Our Ref: GMC:LY:37315

17 April 2026

**Letter of Objection to proposed State Significant Development
Property: 65 Muston Street, Mosman (SSD-98068713)**

Image 2 – Registered Surveyor assessment of walking distance (418.3m)

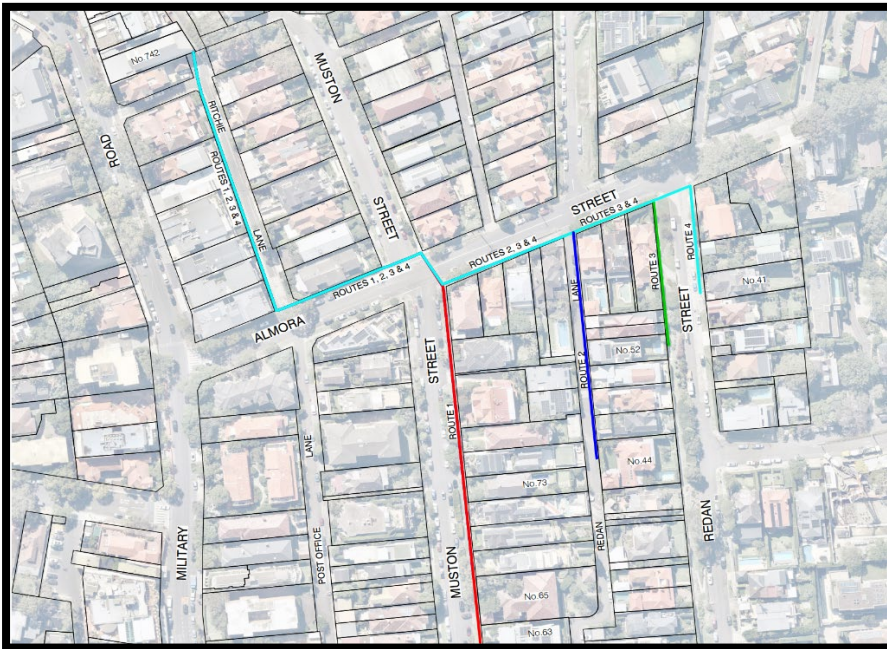
The application is supported by a Surveyors Report and accompanying ‘Plan showing route of pedestrian travel distance from 65 Muston Street’. The walking route to the South-East corner of the ‘Spit Junction Town Centre’ shows the subject site to be within 400m walking distance to the Town Centre, however the accompanying report does not confirmed this is via a safe and accessible route.

The distance to the site from the Town Centre is required to be verified to have been correctly applied in line with the legislative requirements outlined in the State Environmental Planning Policy.

The walking distance along a safe path identified by Survey provided in support of this submission is 418.3m.

The consequence of this measurement is significant given the legislation specifies applicable floor space ratio based on the sites distance to the Town Centre. From our assessment, the site is located in an outer area, being within 400m- 800mm safe walking distance.

Image 3 – section showing basement protruding above ‘existing ground level’

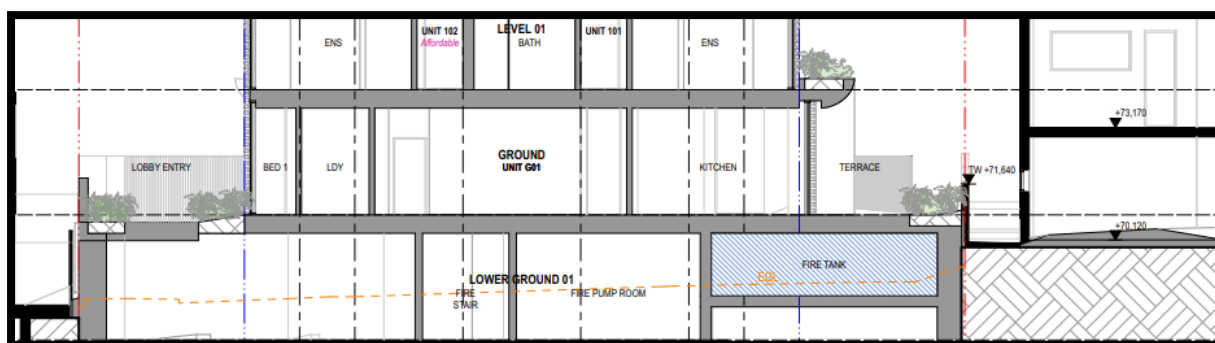
According to the State Environmental Planning Policy (Housing) 2021, where a basement protrudes 1 metre or more above the existing ground level it is generally included in the calculation of Gross Floor Area (GFA). According to the section image below, the basement extends more than a metre from existing ground level to the south, and is therefore to be included in the GFA calculation.

Image 6 – solar plans for 28m building each hour from 9am – 3pm

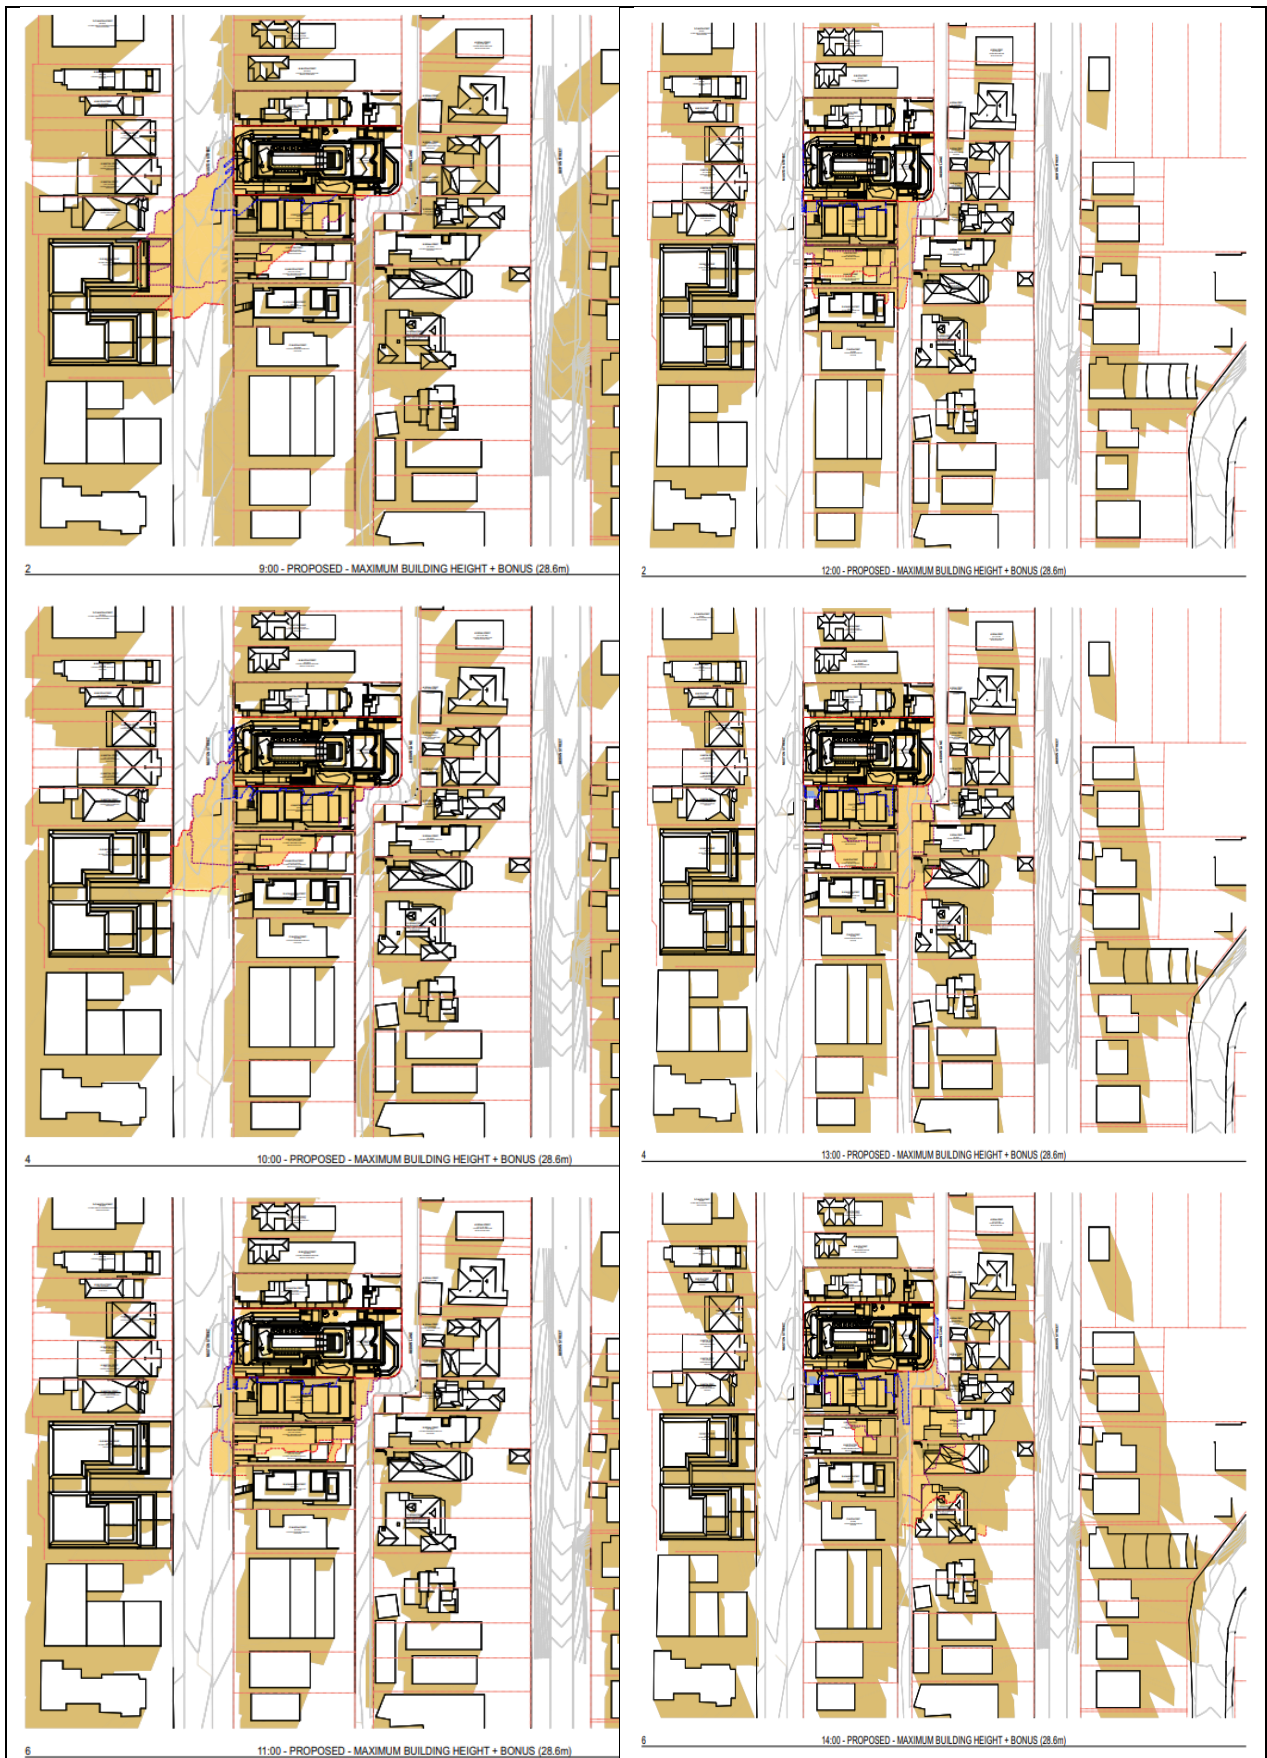
The shadow diagrams confirm the extent of solar access reduction. This is significant to the adjoining owners to the south, for every hour shown on the plans, for a development to either 22m or 28m in height.

The impact of the built form to 28.6m is shown below for the winter solstice when sunlight is most needed.

Our client currently enjoys solar access for all hours of the day, including to a north facing courtyard. The loss of amenity this proposal will result in is immeasurable should this building proceed.

Image 7 – view of the proposed new building overlooking to the south

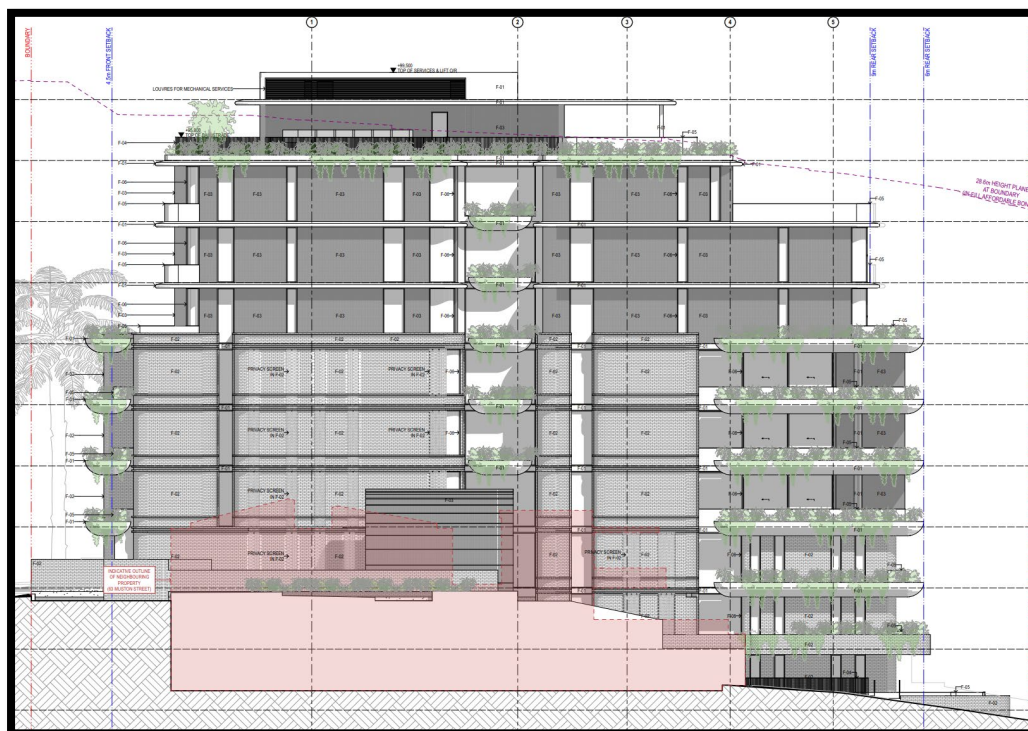
The proposal will have real, enduring and negative privacy impacts for neighbouring residents. Direct view lines, including from communal and circulation spaces, will be possible. This includes direct downward looking from upper floor windows and elevated balconies.

Proposed privacy screening will not defeat the perception of overlooking and loss of privacy, resulting in a loss of residential amenity and enjoyment of the private spaces of adjoining residents.

Image 9 – Landscaping plan with low planting to side boundaries

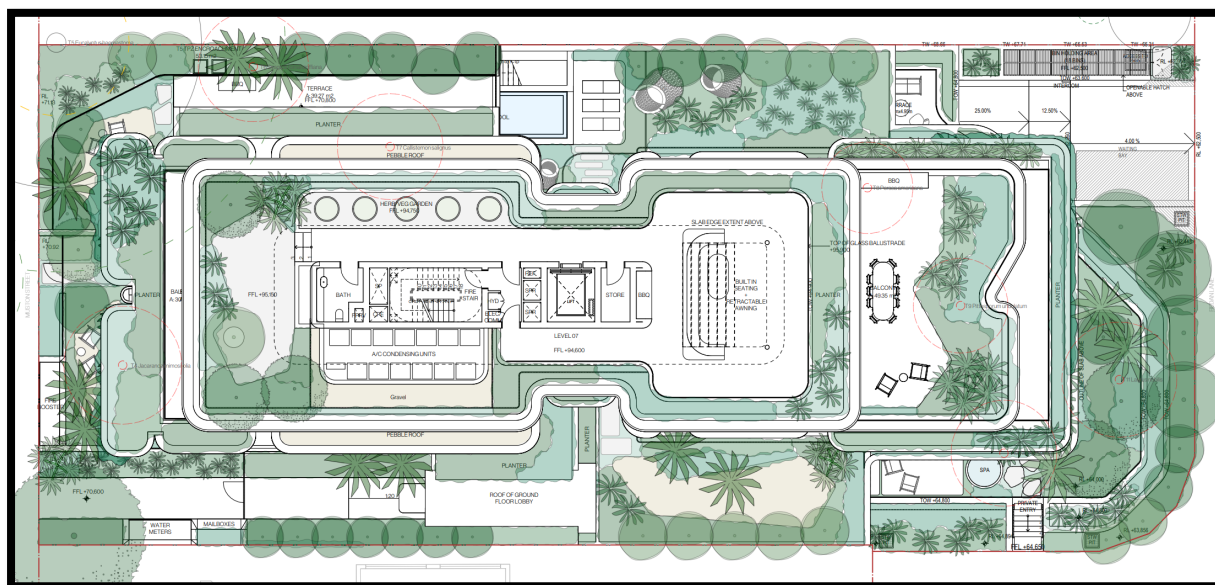
The Landscape Plans prepared by Dangar Barin Smith provide for a deep soil area of 135.73m² or 10.1% mainly within the front and rear setbacks. Large trees, that require deep soil planting and assist in screening the development to adjoining owners is not provided to the side boundaries where they can be most effective.

The proposal seeks to demonstrate compliance mainly through the use of planters which will only provide low level benefits and softening to this large built form.
